**North Rockland High School Projects – Phase 2**

**MSA File No. 43045**

**NOTICE TO BIDDERS**

Re: **ADDENDUM NO. 1**

8 CATCH BASIN  
Scale: N.T.S.

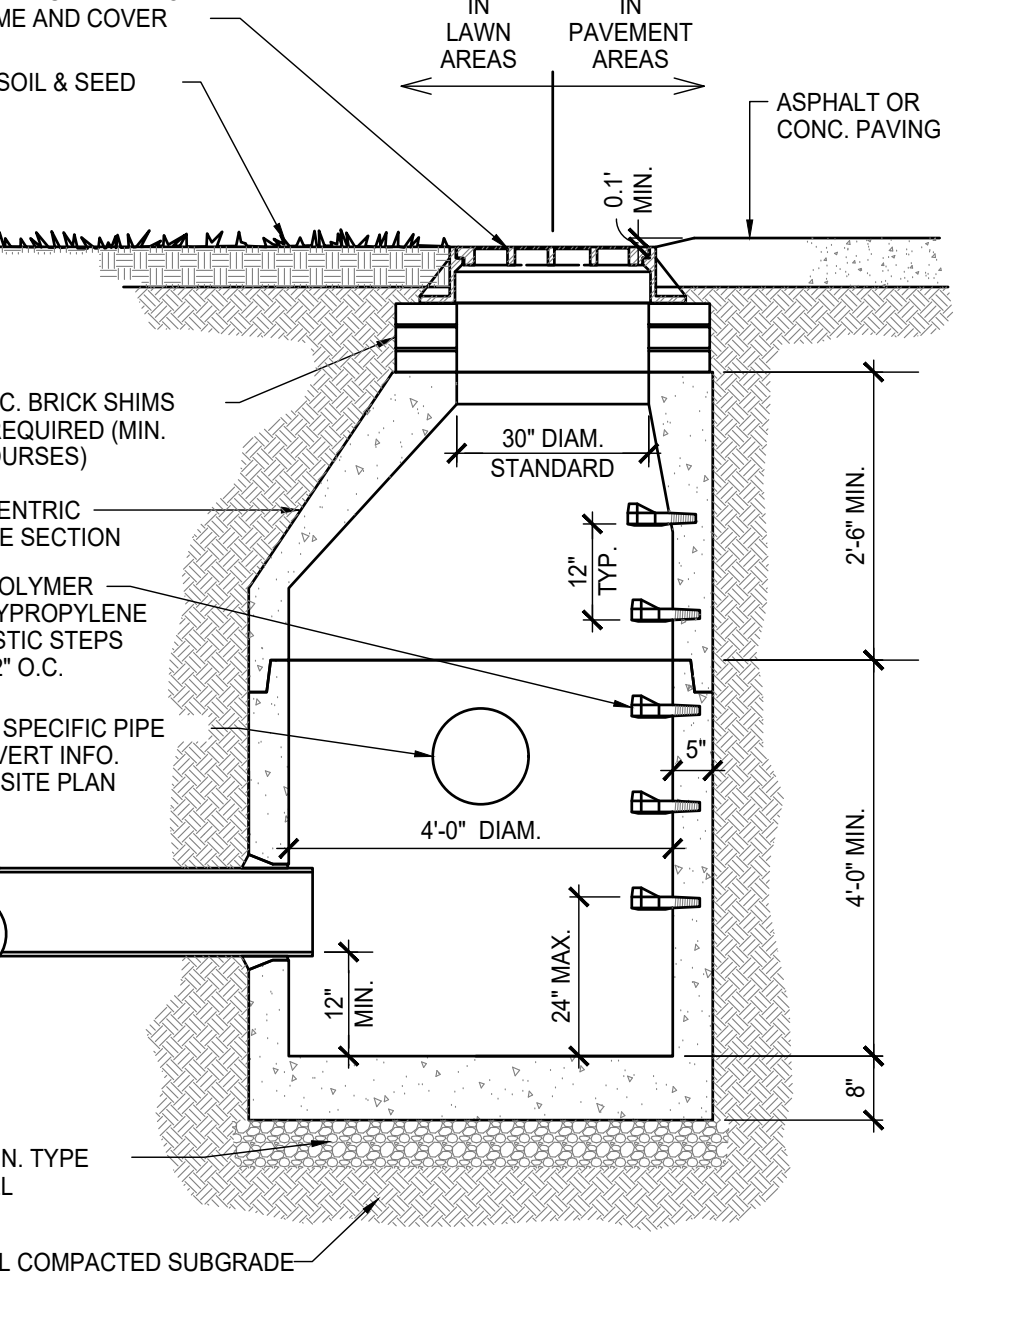
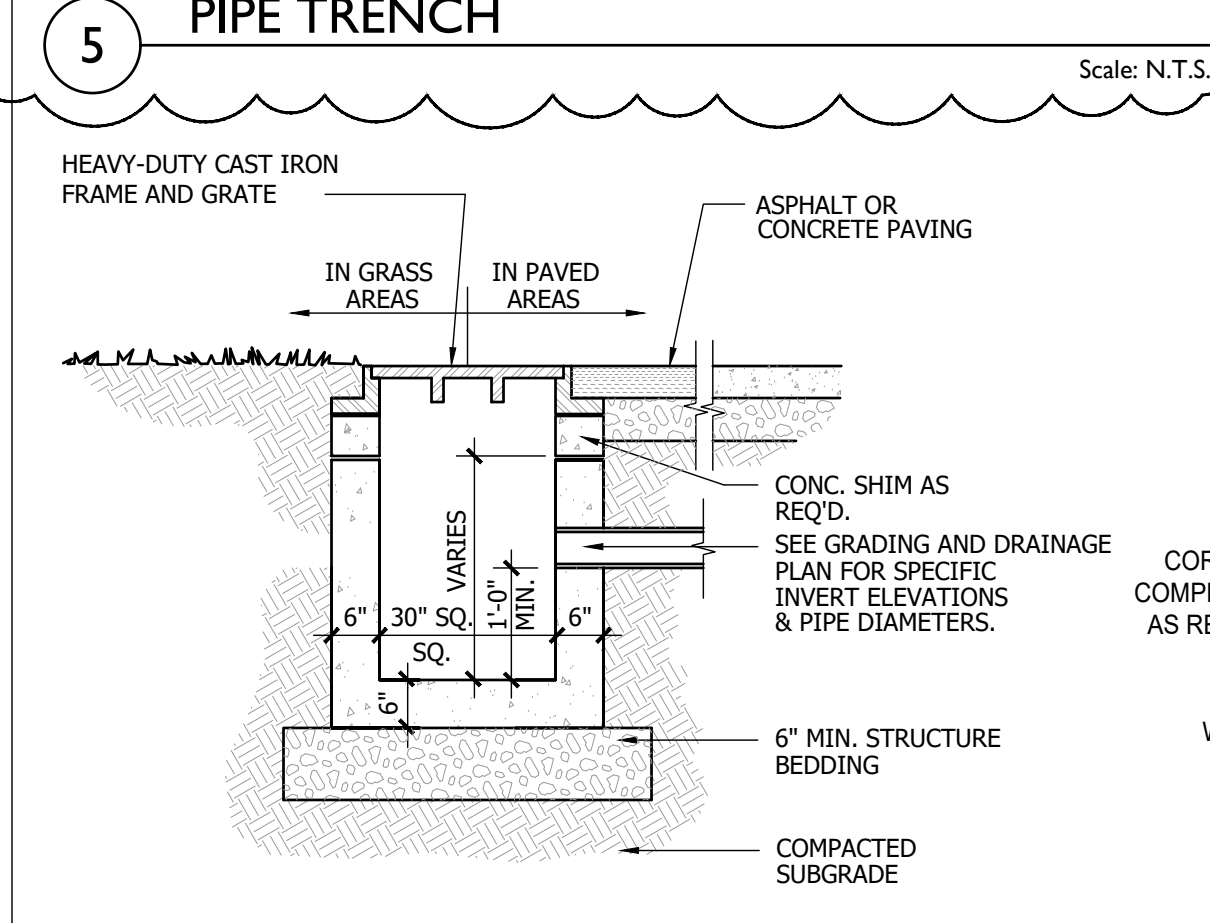
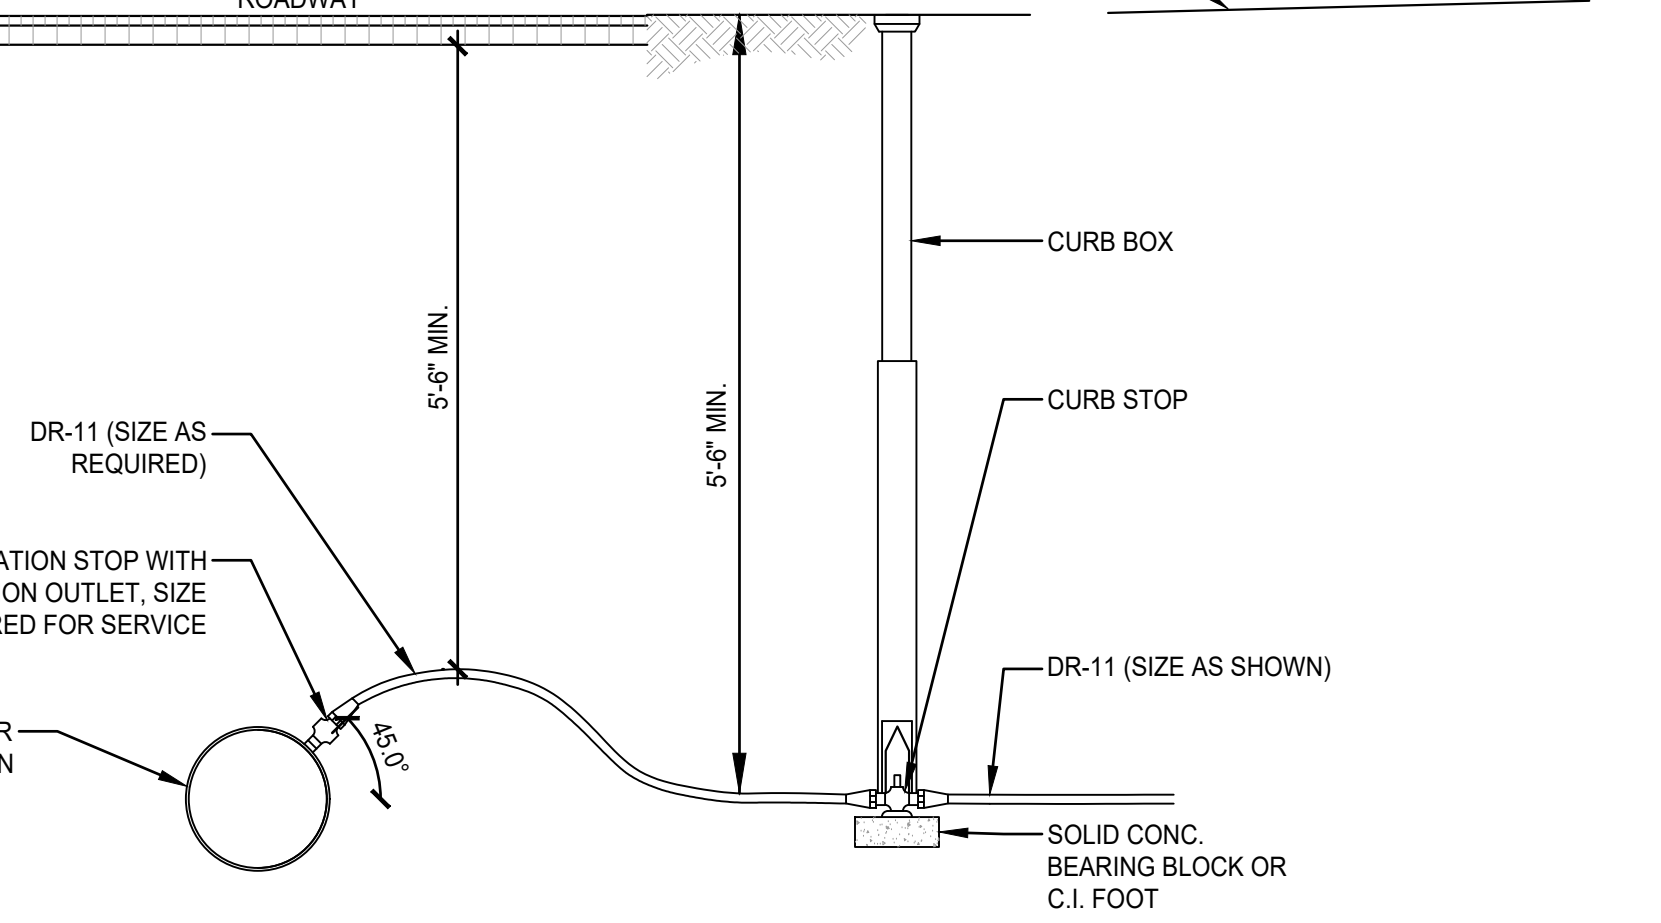
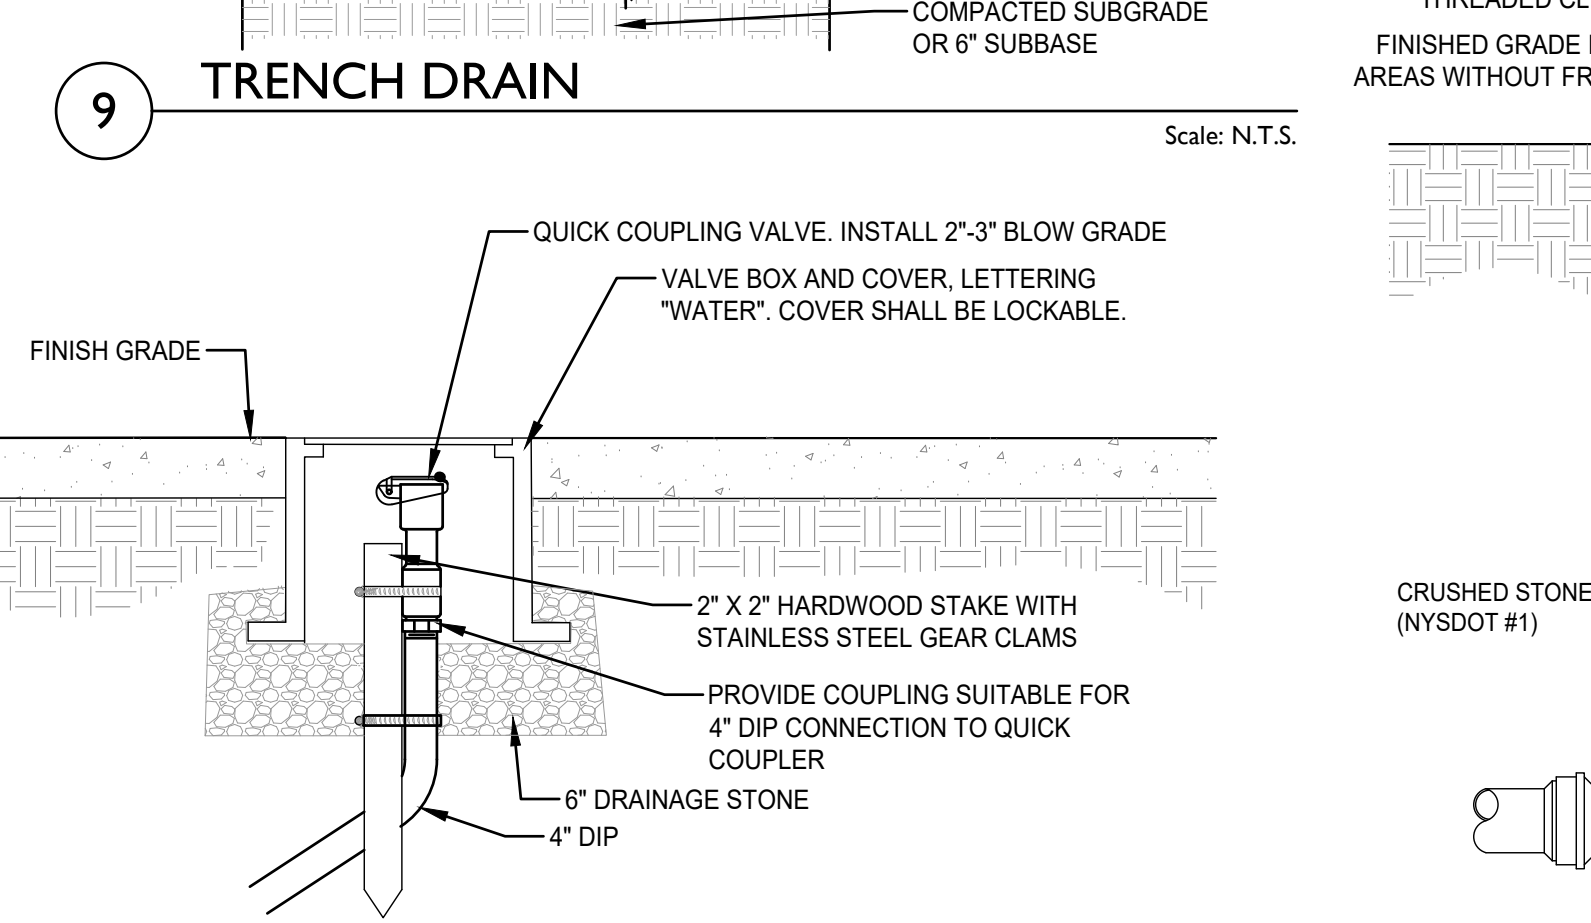
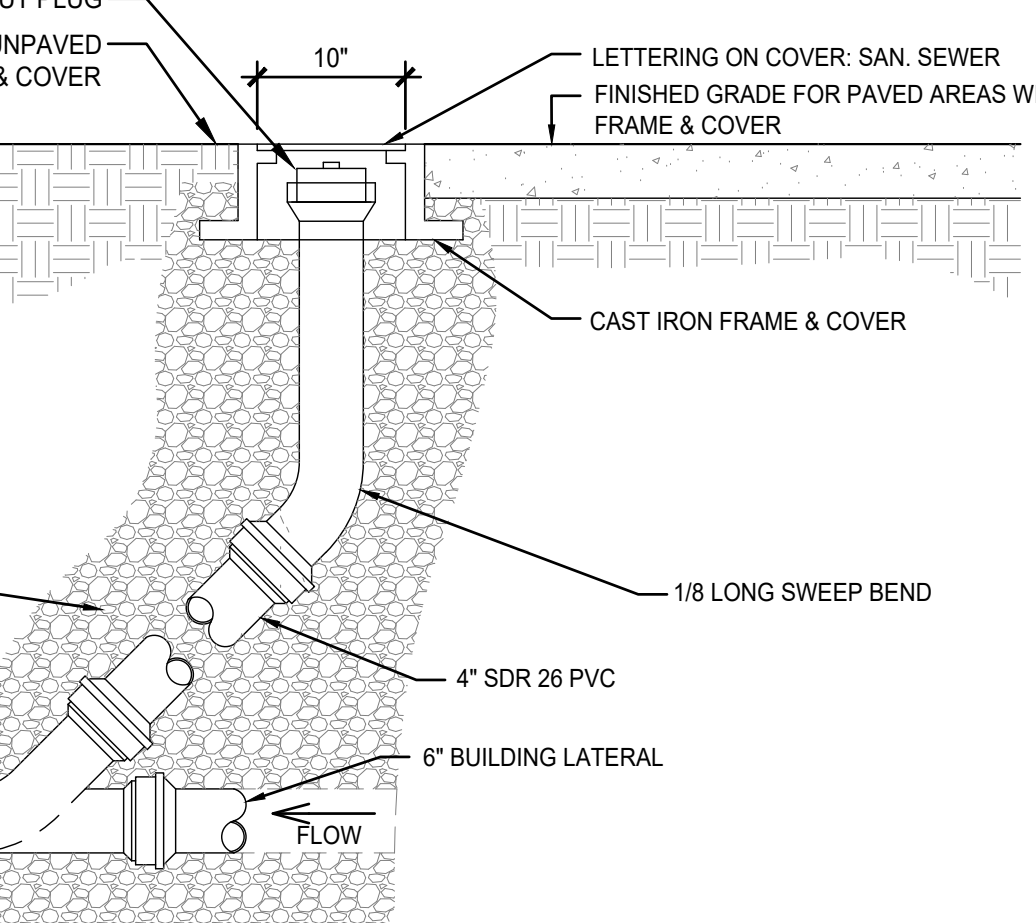
Please see revisions to drawings C-410, C-420, and C-720 for locations where changes in grade will require existing active 4" and 8" water lines to be lowered to maintain proper burial depth. Bidder shall carry cost in base bid to cut and replace sections of 4" and 8" water lines in areas shown. Bidder shall also carry cost in base bid for adding insulation over existing water lines where shown. Existing detectable warning tape shall be replaced in all disturbed locations.

Drawing No.  
**CE-102**

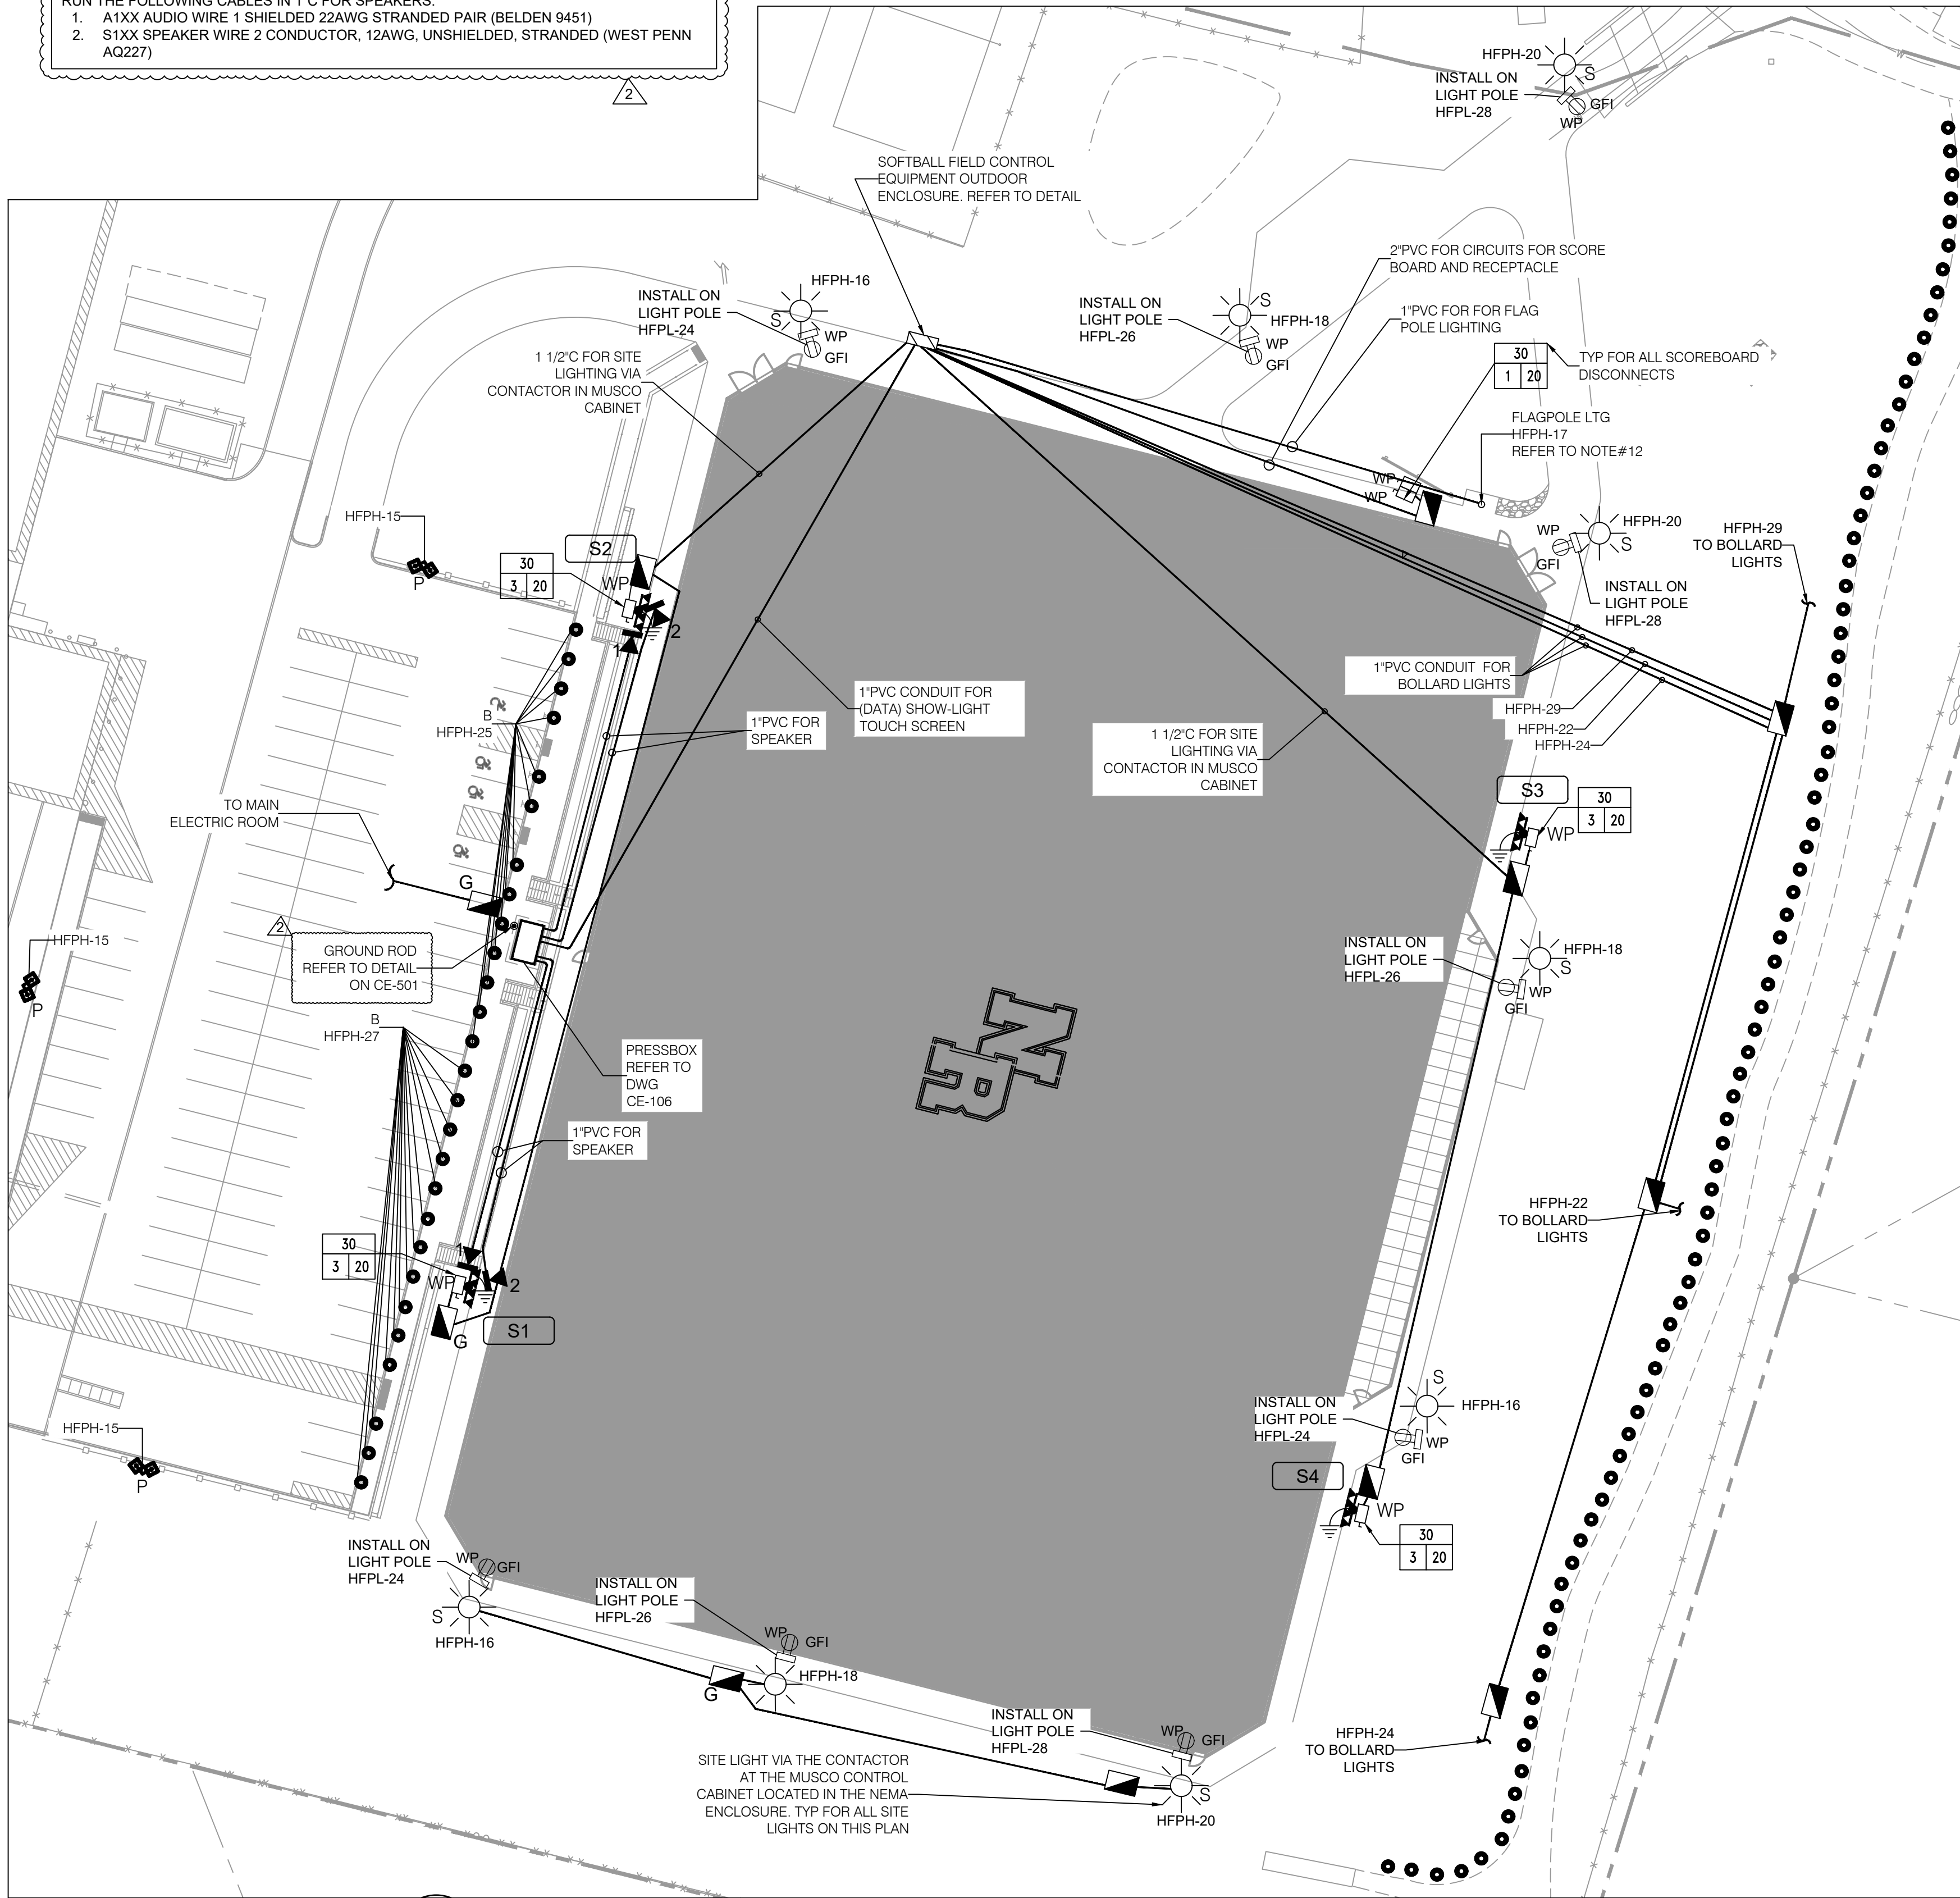
11) See attached revised drawings CE-102, CE-103, CE-501, CE-502, CE-503, CE-504 and CE-505 for updated sound system, controls and grounding detail.
